Access Compliance Report

Public Rights-of-Way

(Curb Ramps)

Intersection ID: 10041935	Main Street: WINDING_RIVER_DR	Cross Street: N/A	Location: S
ADA ID: F3B7D9356FD6	Ramp Type: Perp	Initial Pass/Fail: Fail	Overall Compliance: No
Severity Score: 37.5			
Codes/Mitigation Info/Possible Solution		Field Measurements/Component Compliance

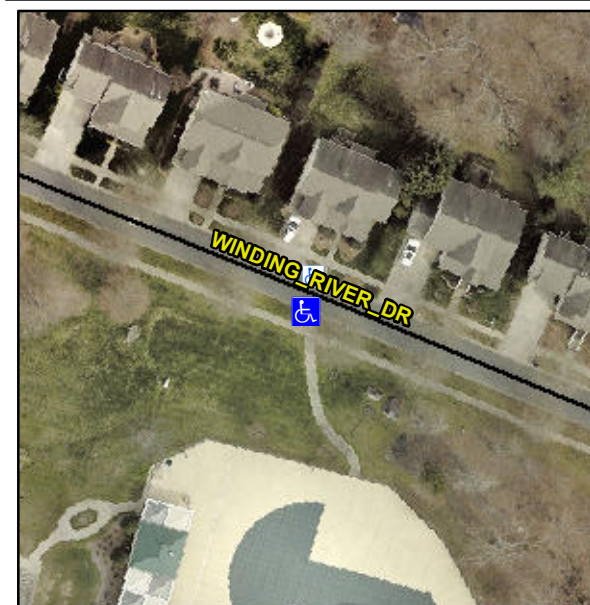
Not Found, R304.2.2, R304.5.3

Compliance	Description	Data	Compliance	Description	Data
N/A	Ramp Length (in)	43.5	No	Ramp Slope (%)	12.7
Yes	Ramp Width (in)	48.0	No	Ramp XSlope (%)	6.8
N/A	Flare Type LT	N/A	N/A	Flare Type RT	N/A
N/A	Flare Slope LT (%)	N/A	N/A	Flare Slope RT (%)	N/A
N/A	Flare Traversable LT?	N/A	N/A	Flare Traversable RT?	N/A
N/A	Landing Length (in)	N/A	N/A	DWS Provided?	N/A
N/A	Landing Width (in)	N/A	N/A	DWS Contrast?	N/A
N/A	Landing Slope (%)	N/A	N/A	DWS Length (in)	N/A
N/A	Landing X Slope (%)	N/A	N/A	DWS Full Width?	N/A
N/A	Landing Curb? (Y/N)	N/A	N/A	DWS Offset (in)	N/A
N/A	Shared Landing?	N/A			
N/A	Gutter Ponding?	N/A	N/A	Gutter Slope (%)	N/A
N/A	Gutter Lip Ht (in)	N/A	N/A	Gutter X Slope (%)	N/A
N/A	Painted X Walk1?	No	N/A	Painted X Walk2?	N/A
	X Walk 1 Direction	To N		X Walk 2 Direction	N/A
N/A	X Walk 1 Width (in)	N/A	N/A	X Walk 2 Width (in)	N/A
	X Walk 1 Slope (%)	7.1		X Walk 2 Slope (%)	N/A
	X Walk 1 X Slope (%)	1.2		X Walk 2 X Slope (%)	N/A

Remove & Replace Entire Ramp.
